**2X800 MW Gadarwara MRS  
Reply Of Prebid Clarification**

**NATIONAL THERMAL POWER CORPORATION LTD.**  
POWER SECTOR  
GADARWARA SUPER THERMAL POWER PROJECT  
STAGE-I (2 x 800MW) UNIT # 1 & 2

TITLE: TG EQUIPMENT PLAN AT EL 18.0 M

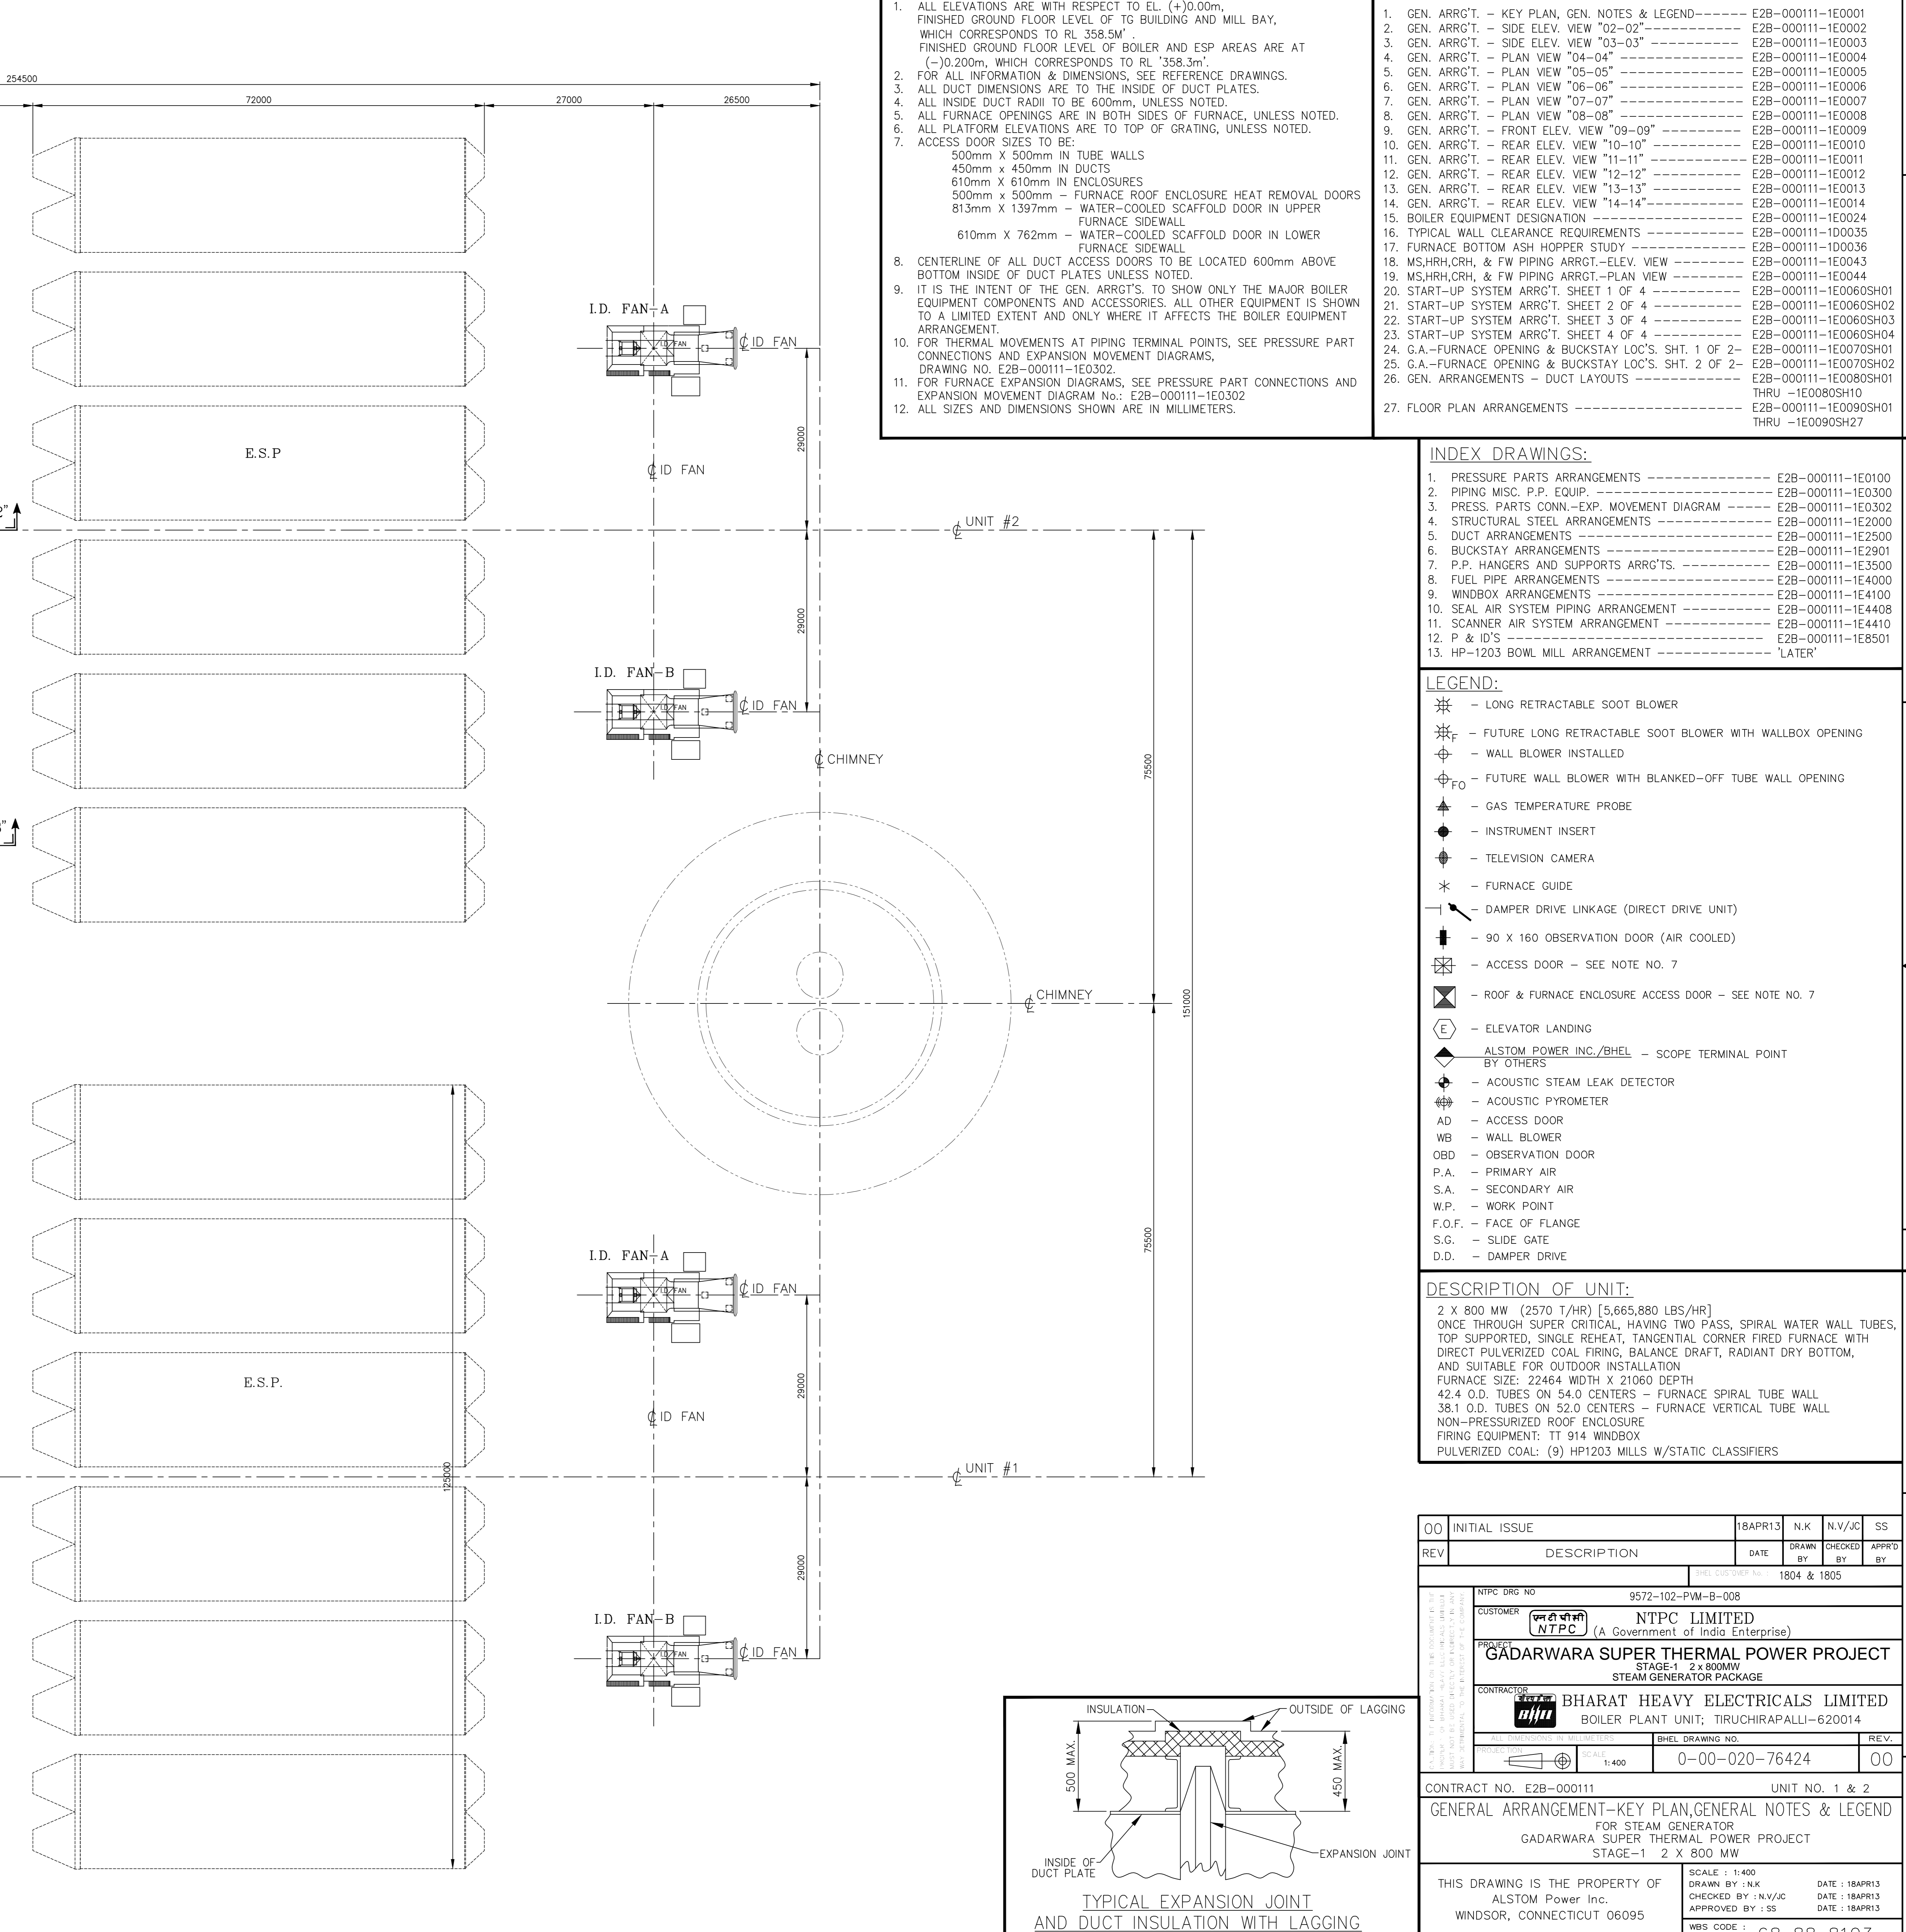
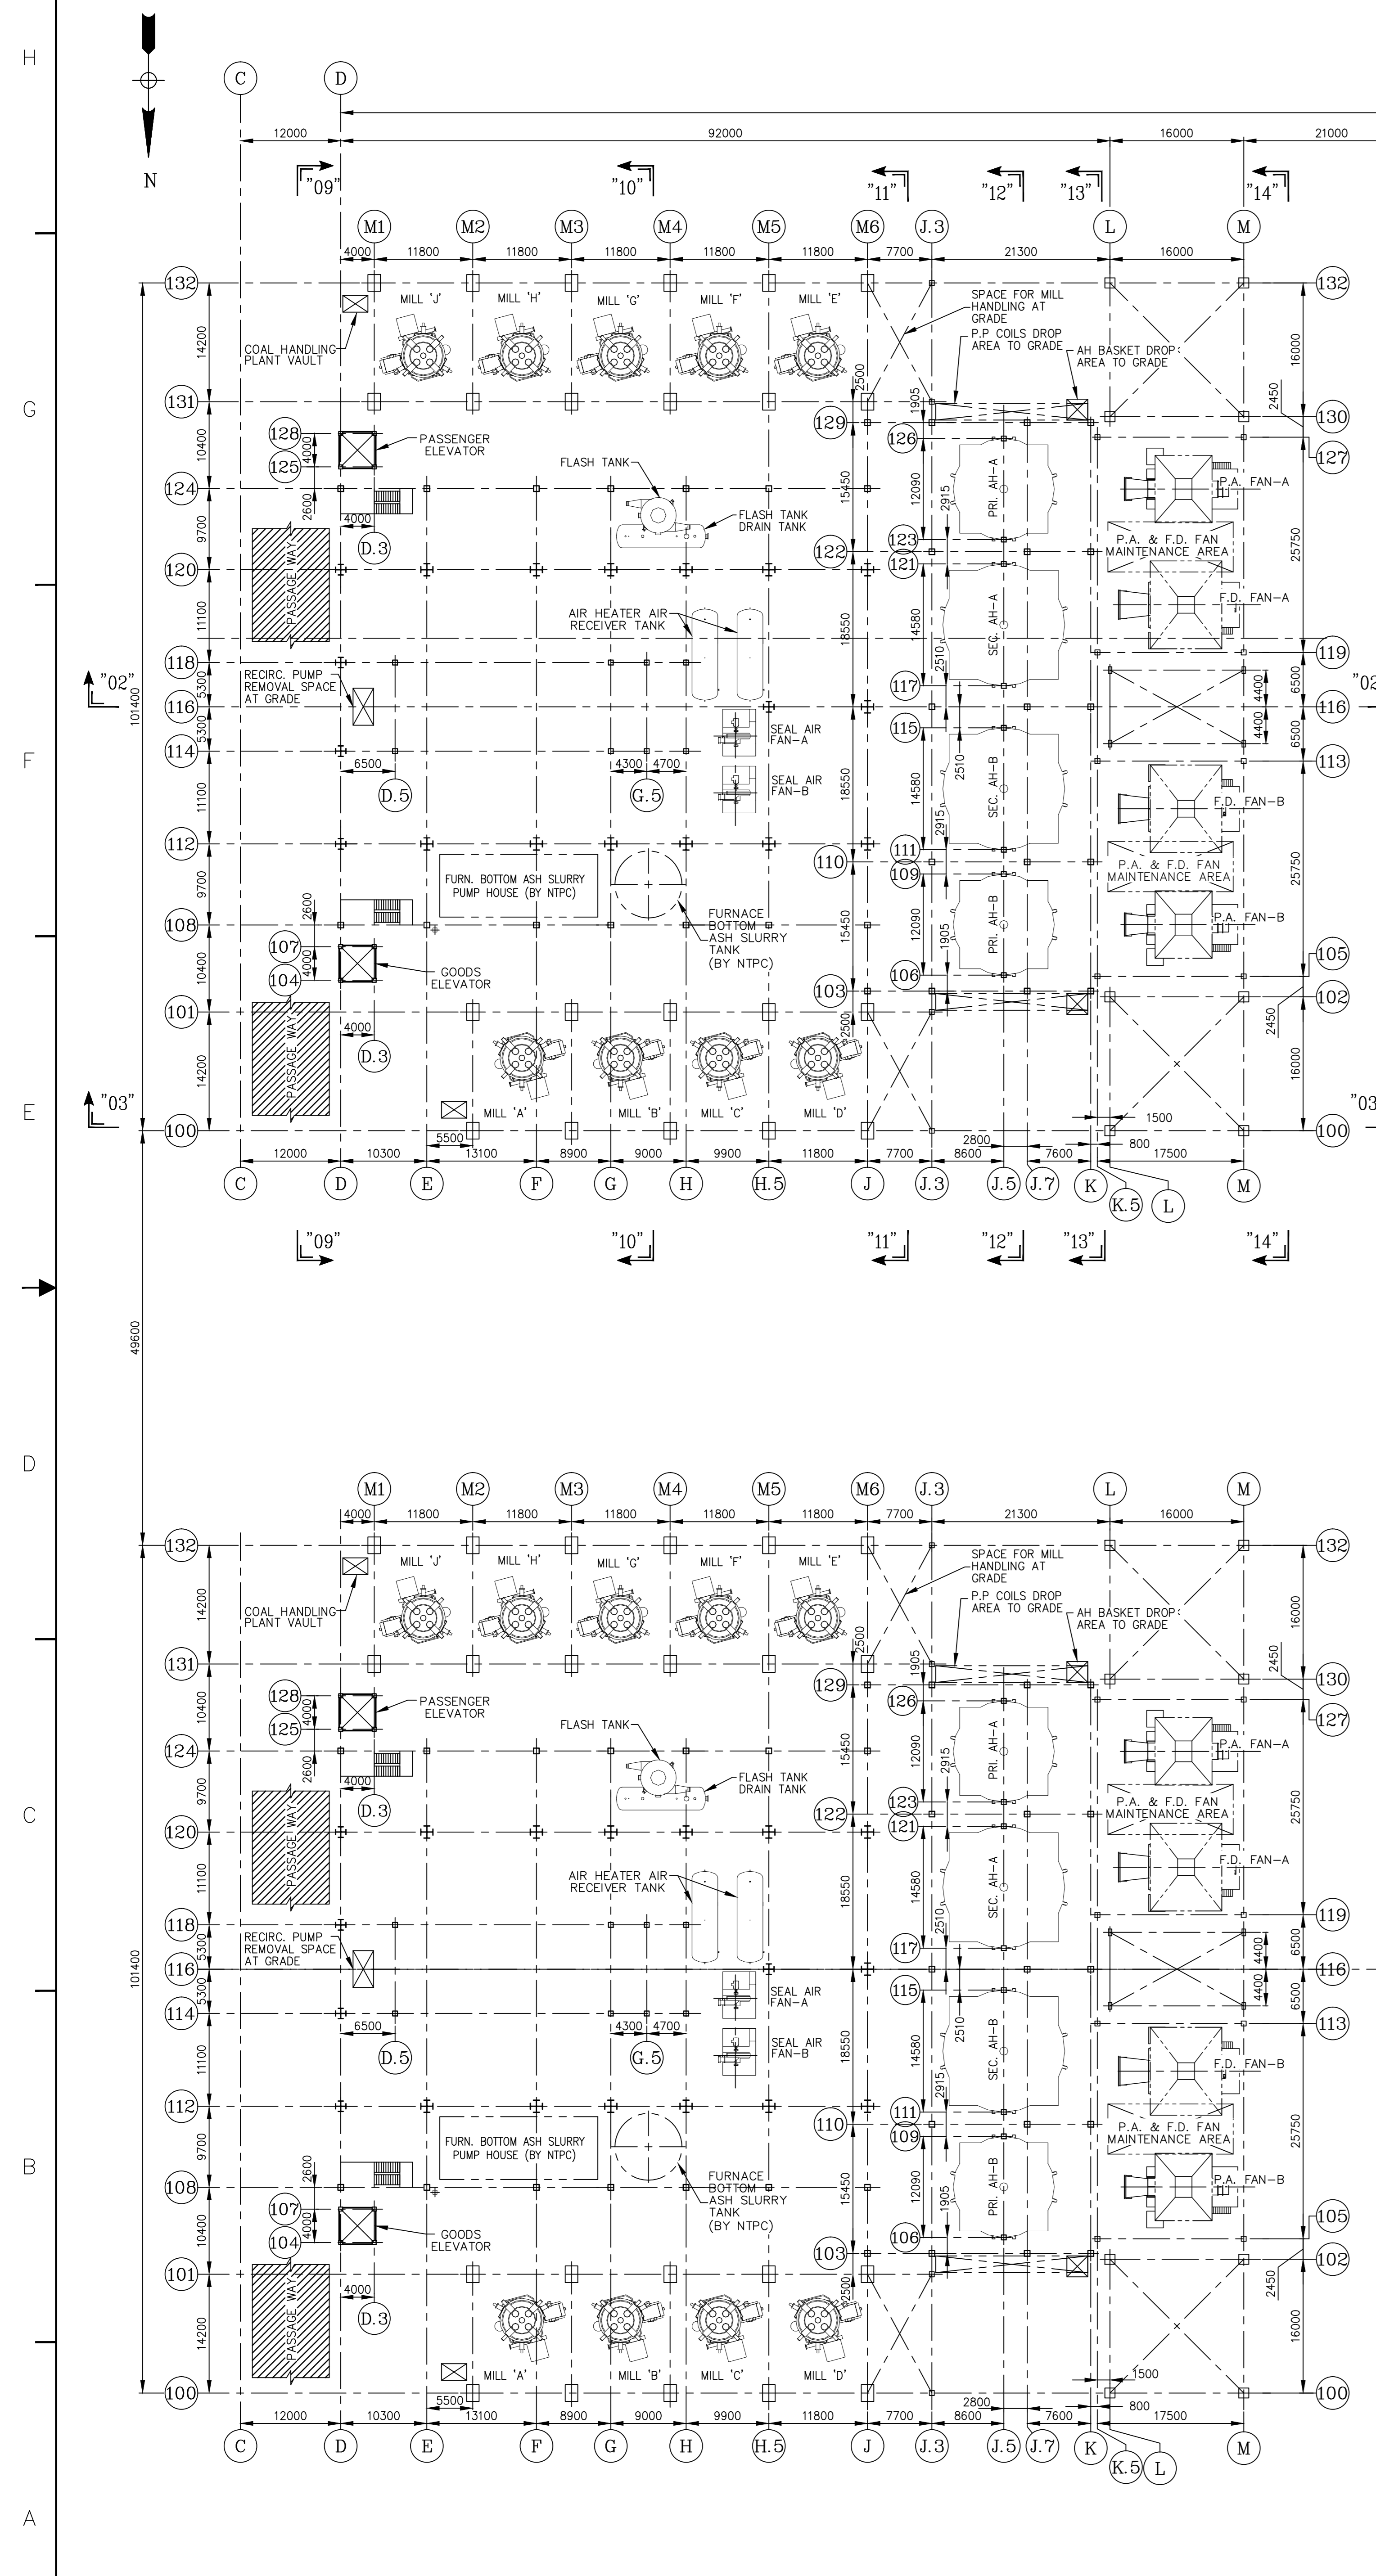
6	Annexure-I to Section C: Electrical Scope Matrix rev-0	5(b)	Our scope shall be limited to supply of branched cable trays for cables in our scope. Maximum length of branch cable trays shall be limited to 10 meters only.	Bidder to kindly refer MEP at 0.0 M (attached) wherein pipe cum cable rack has been shown. Any branch cable tray from these pipe cum cable racks is in bidder's scope.
7	Annexure-I to Section C: Electrical Scope Matrix rev-0	7	Since we are offering branched cable trays for cabling between equipments supplied by vendor in view of the same MS conduits will not be supplied.	Specification requirement is clear. Bidder to follow specification.
